# NORTHERN VIRGINIA TRANSPORTATION AUTHORITY

## FY2020-2025 SIX YEAR PROGRAM

### PUBLIC COMMENTS

**Northern Virginia Transportation Authority**  
**Summary of FY2020-2025 Six Year Program Public Comments**

## W&OD Trail Widening Not Needed – Second Parallel Four Mile Run Trail Exists

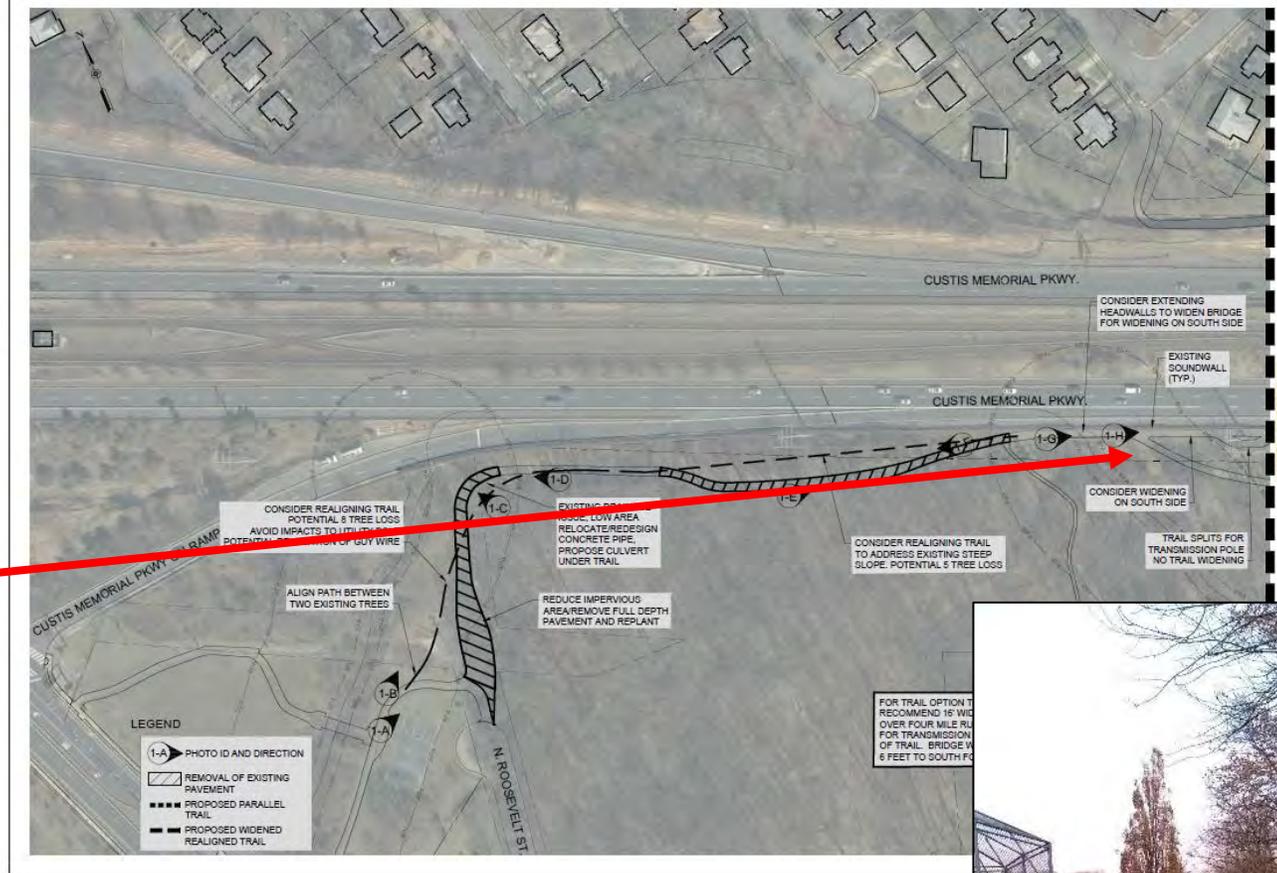
- There are two separated trails for most of the length of the project
- Capacity exists for commuting hours
- A costly widened trail would still have biker-ped conflicts. Better traffic management of existing trails would be a cost effective way to reduce perceived commuting hour conflicts

Four Mile Run trail parallel to W&OD trail near East Falls Church Metro (western end of proposed project)

## Tree Impact of W&OD Trail Widening Proposal

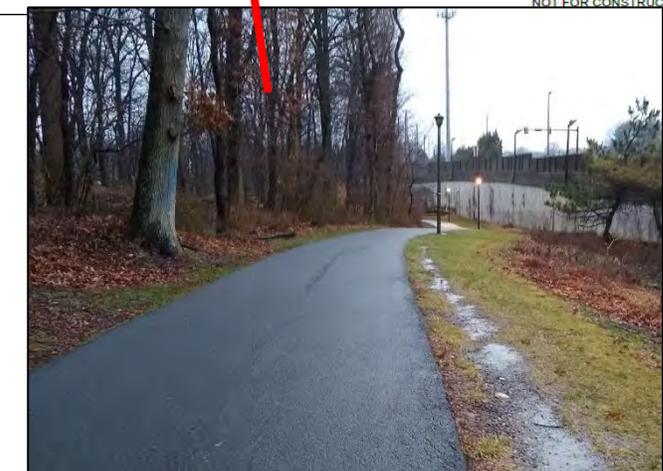
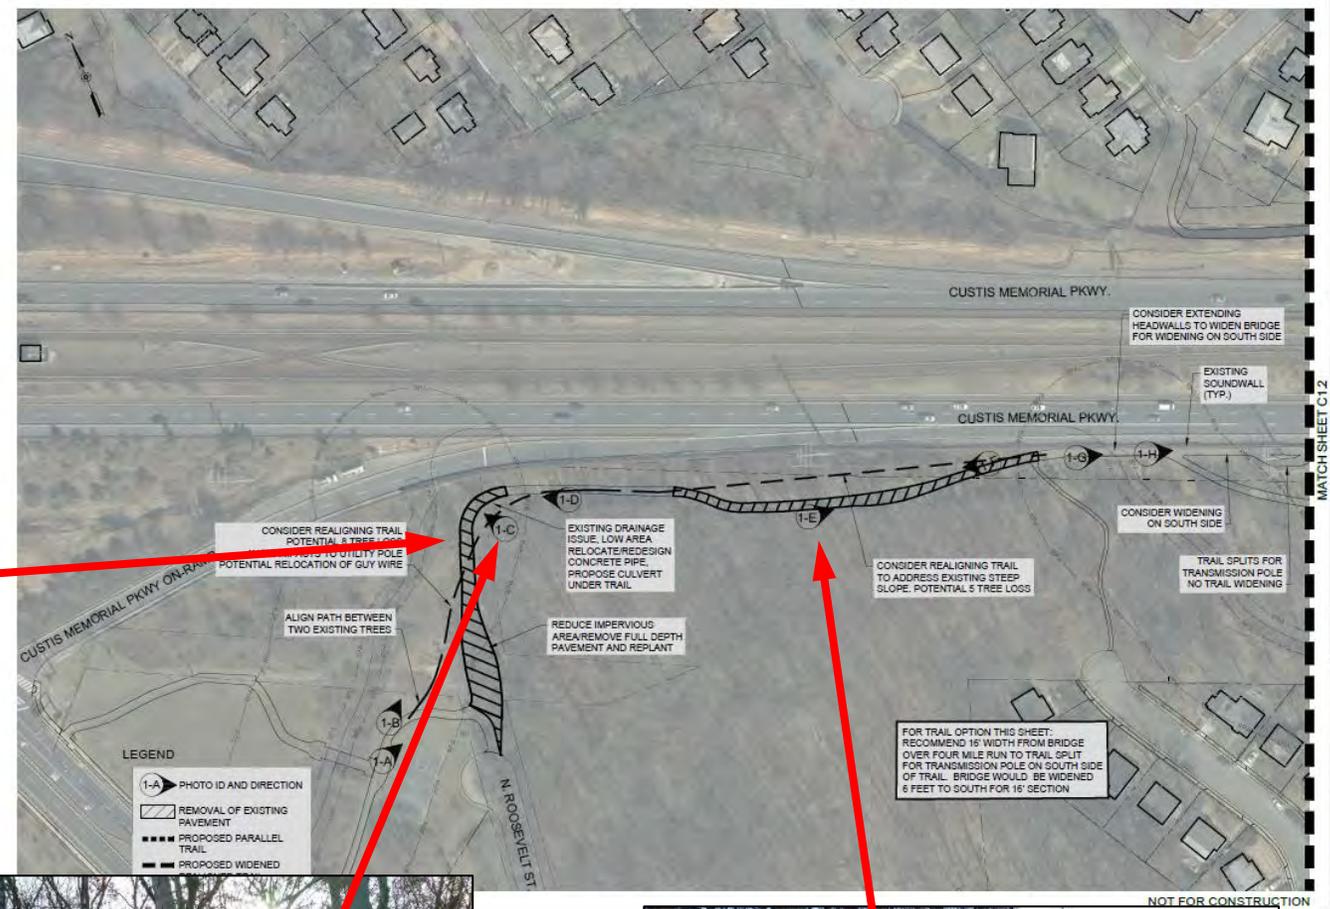
- A number of large mature trees would be cut down near N. Roosevelt Street at Brandymore Castle to straighten and widen the trail
- Others might be cut down or endangered by the work
